Balboa Park Reservoir – D7 - D11 Districtwide Transit Impacts

"Who should sit at the table when development policy matters that impact the general public are being decided?"

Aaron Goodman (BPS CAC – Seat 8 (Families + Children)

FIGURE 7: EXISTING AND PROPOSED OPEN SPACES IN PLAN AREA

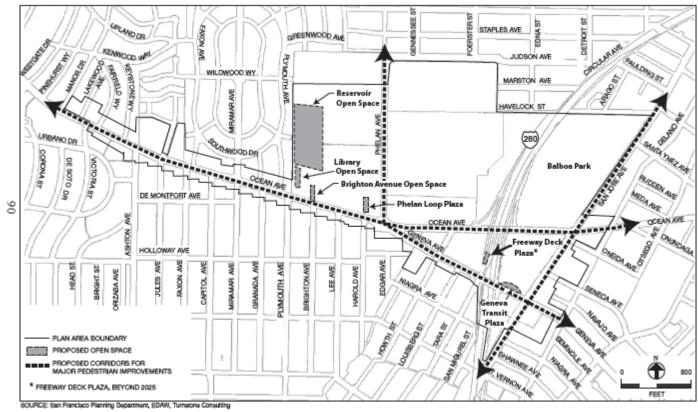
The prior community meetings noted possible "reservoir" open space. The current push to turn public sites into development land, ignores the prior community proposed future use as a public open space for recreation on the western side of the 280 freeway. Ammenities currently do not sufficiently meet the increased population needs of the two districts.

Existing height and bulk limits, are being used to develop land-use controls, on both sides of the area, but the Balboa Reservoir CAC did not include a D11 representative though parcels shown in the land-use and prior slides indicate a joint area planning effort.

FIGURE 1: PROJECT LOCATION

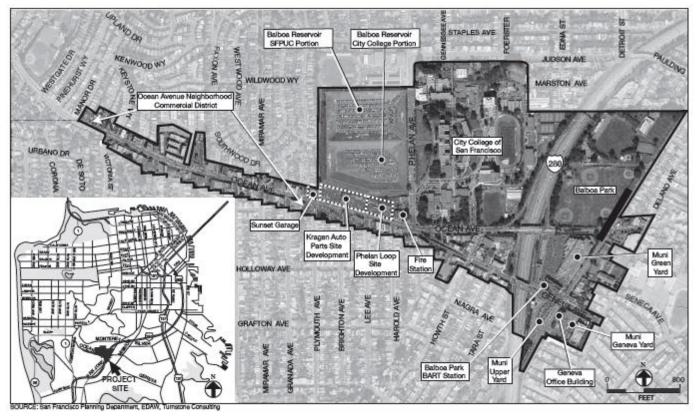
It is key to note the issue of number of units @ 500 possible, and a large new public open space. This is contingent if the SFPUC decides to "abandon" the site for water storage.

If the public's greatest need is related to Water and the current drought, along with housing as an equally pressing need, is housing need the only function of the site that should be considered?

Should the public's views and need's be openly vetted?

The site's location and impacts were defined in the Balboa Park Station Area Plan EIR by a joint committee who did excellent work in defining the area's impacted, and the need to look wholistically at the entire district inclusive of D7 and D11. I would strongly suggest we continue this effort by including the D11 and community based representation required, including adjacent schools, and neighborhood organizations. Regardless of the size of the panel required, if needed the mayoral appointee's should defer to the communities needs due to the public land concerns of the site.
